HISTORICAL LANDMARK COMMISSION STAFF REPORT

Stevens Garage New Construction 58 South 1200 East PLNHLC2009-01224 December 2, 2009

A SOUTH ELEVATION
 SCALE: 1/4" = 1'-0" (24:504)
 SCALE: 1/8" = 1'-0" (11:817)

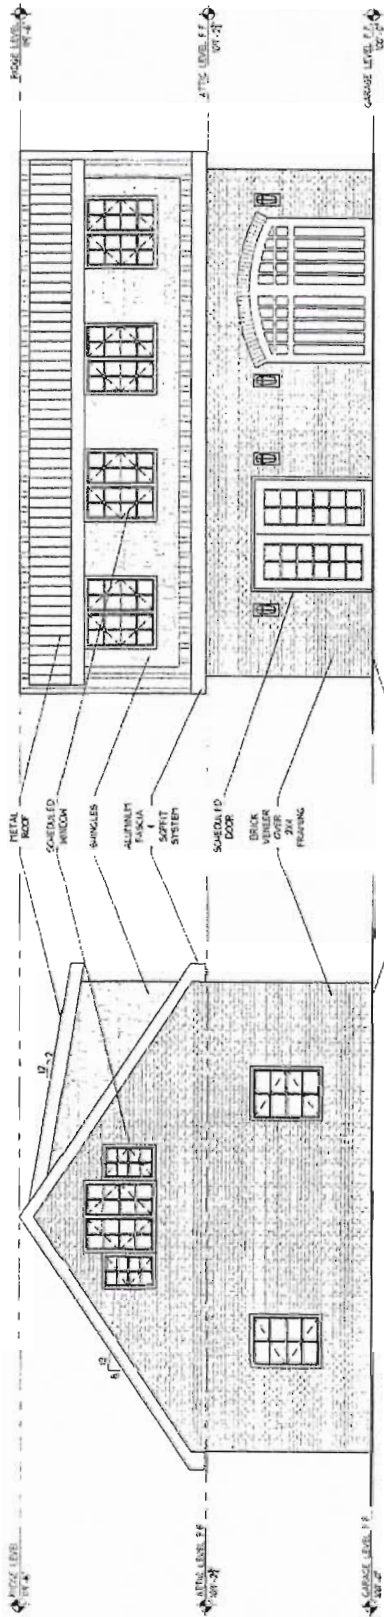
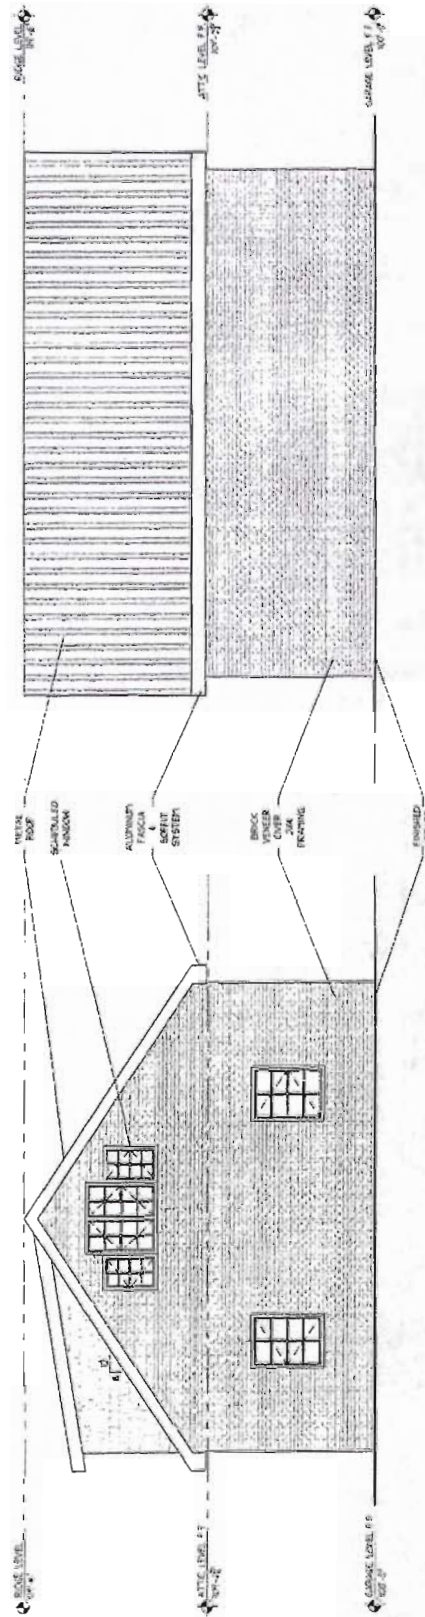
The principal structure has a front gable roof similar to the majority of the existing garages. The proposed accessory structure will be unique with its side gables and two large shed roof dormers.

Finding: The proposed accessory structure is different in architectural style, orientation of the roof, height, and material from the principal structure and from the majority of the accessory structures in the block. The proportion and height of the proposed structure is not subordinate to the primary building. The proposed accessory structure does not fit this standard.

Analysis: The proposed accessory structure proposes to use materials that are different from the materials used on the principal structure and in the neighborhood. The use of metal shingle roof is not common in the surrounding structures and streetscape.

Finding: The materials proposed on accessory structure are not visually compatible with those utilized in the primary building or materials found in the neighborhood. The project does not meet the intent of this standard.

See attached redline PDF sheet A002.

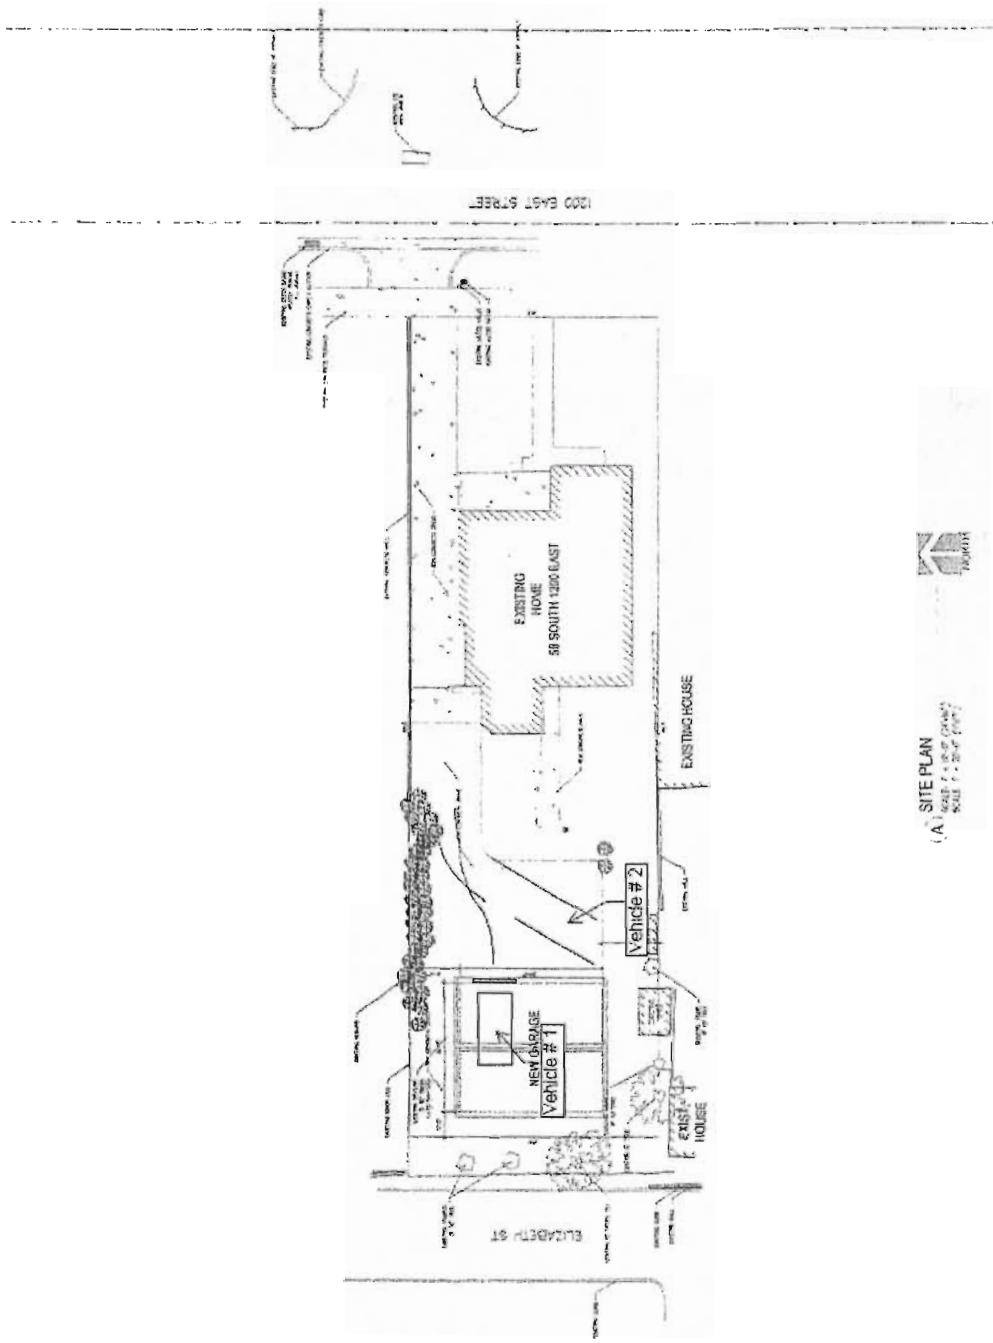
The proposed garage is shown for only one parking stall. The second required parking stall (two stalls per single family residence)can be accommodated in front of the building to the south.
